Meeting Date:  
August 9, 2021

Request:  
Conditional Use Request for a  
16- unit townhome  
development

Case Manager:  
Nick Sugar, City Planner

Hudson Planning Commission	CONDITIONAL USE REVIEW
Case No. 2021-539	August 9, 2021

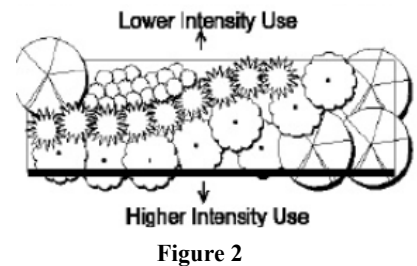
Comment: The LDC requires a minimum Bufferyard D (25ft) along the western property line for townhomes adjacent to commercial uses. While the applicant has submitted a revised landscaping plan

with additional plantings, those plantings are not distributed within the required twenty-five (25) foot width.

The revised submittal depicts a Bufferyard C (15 ft) to the south and east to improve the compatibility and to provide improved protection for existing trees adjacent to the property line. A final landscaping plan would be reviewed through the site plan review.

The applicant has also revised the landscaping plan to show a six foot (6) foot vinyl privacy fence along the southern property line. Staff notes landscaping/buffering requirements stipulate fencing must be placed closer to the higher intensity use, which, in this case would be the proposed townhomes (see Figure 2). Therefore, the landscaping plan should be revised to depict the plantings directly adjacent to the residential properties, with the fence closest to the townhomes. Staff also recommends a wood fence be proposed as part of the site plan application in lieu of a vinyl fence.
